KENWOOD

Service Bulletin

Subject: TS-50S Mechanical Noise from Final Unit

Date: March 28, 1994

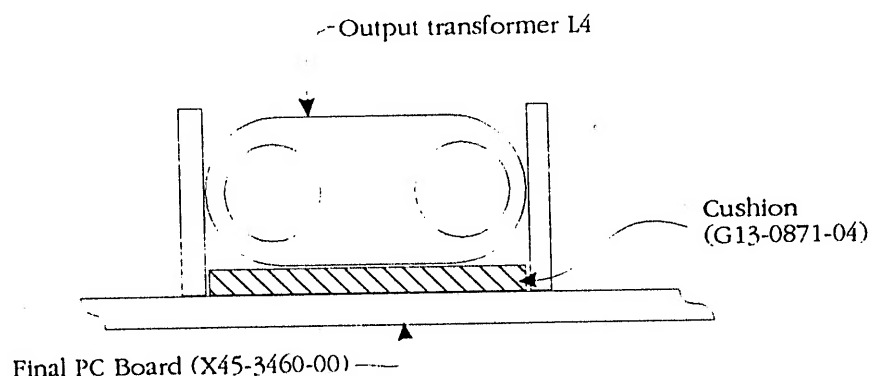
When the transceiver is subjected to vibration a mechanical noise can be heard from the output transformer area. This has led to concern by several consumers that something is loose or improperly installed.

In order to ease consumer concerns you should add a cushion under transformer L4 as shown in the accompanying diagram, and replace transformer L13 at the same time. This transformer has been fastened to the circuit board with high temperature adhesive, so use caution when removing it from the circuit board.
